SB-10043781-9719

Title: TerraStar Headlamp Wiring Harness Rerouting

Applies To: All TerraStar variants

Figure 2 - Headlamp wiring harness (chassis side) in "as-built" location - note pinch point on harness

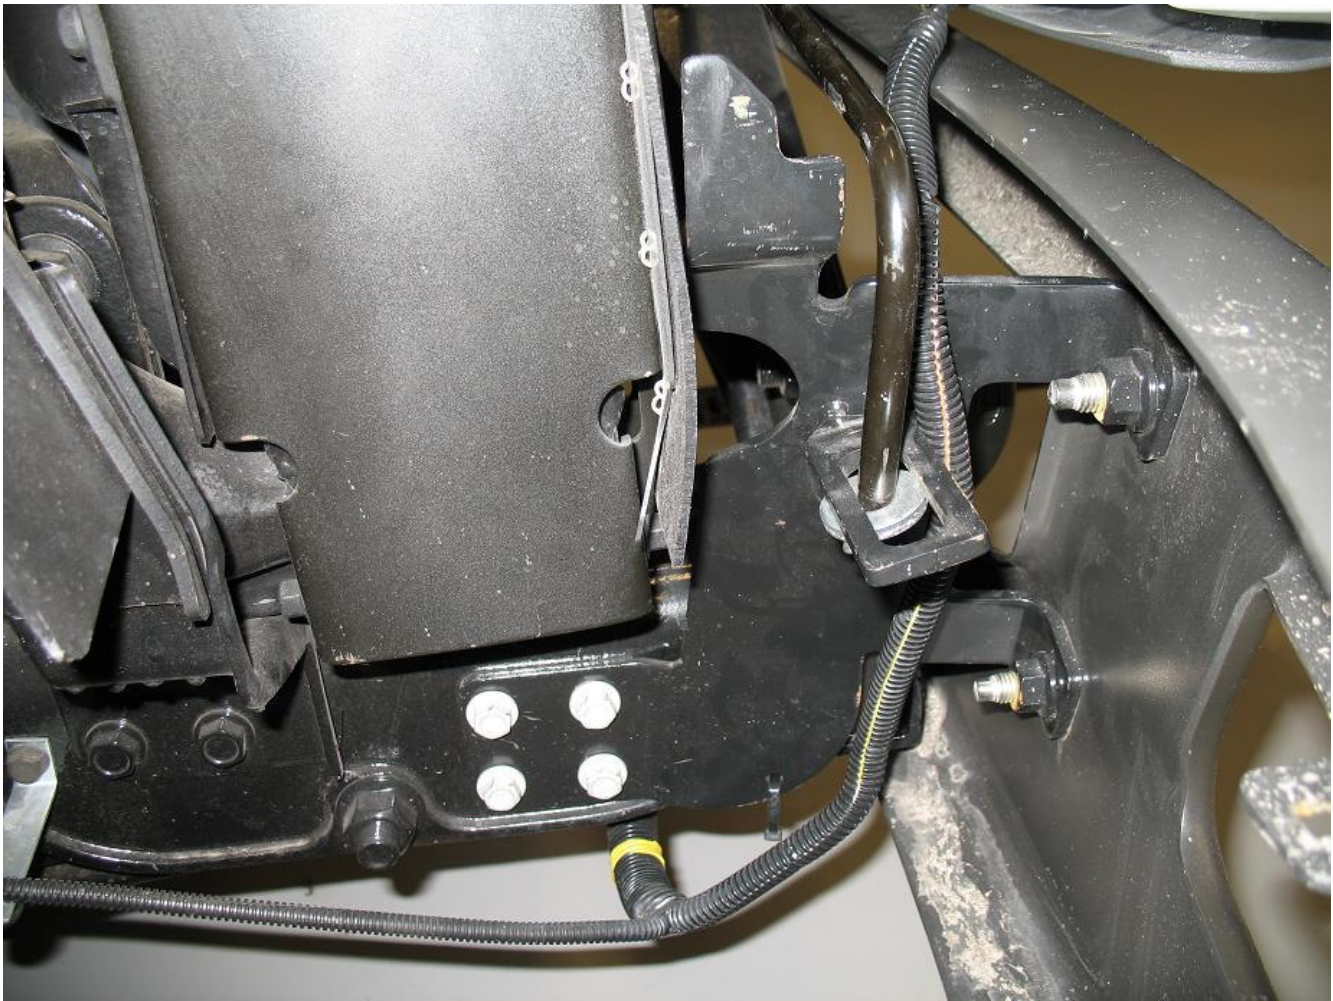
TerraStar chassis-to-hood wiring harnesses for both the right and left side headlamps can exhibit two concerns which should be corrected in the field. The first concern involves the routing of the harness through the hood counterbalance torsion rods, which causes pinching of the harness when the hood is closed. The second concern is a lack of attachment of the harness, from the chassis to the hood.

2) The harness on the chassis side of the connector must be rerouted. Study Figure 2 to determine how the harness will have been positioned in production. In this Figure, note the pinched area on the harness convolute tubing, where the harness has been

trapped between the bottom edge of the hood and the hood counterbalance torsion rods.

Reroute the chassis side harness to the opposite side of the vertical plate which anchors the counterbalance torsion rod. Study Figure 3 (and compare to Figure 2) to determine how the rerouted harness should appear. Secure the rerouted harness to the existing hole at the bottom of the bumper bracket, using one (1) Navistar P/N 289862C1 wire tie. Cut off and dispose of excess wire tie material. In Figure 3, a wire tie has been positioned in the hole, for illustration purposes.
